**TECHNICAL MEMO**

PRODUCT NAME: N4004(S), N6006, F401(s), F601 series camera  
SUBJECT: Countermeasure of broken hook in camera back.

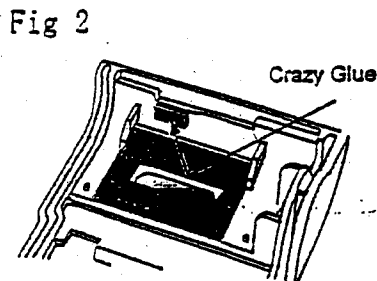
1) Insert the bottom of tweezers into clearance in the back of broken hook. (Refer to figure 1)

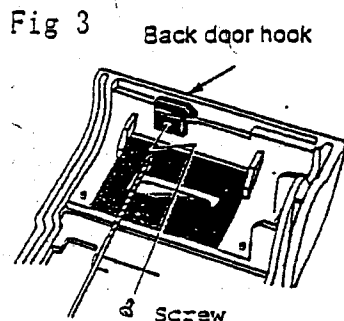
2) Move the tweezers in an arrow direction and break the rising part of hook. (Refer to figure 2)

3) Spread Crazy Glue on the end face of broken part of hook, and mount a back door hook. (Refer to figure 2 and 3)
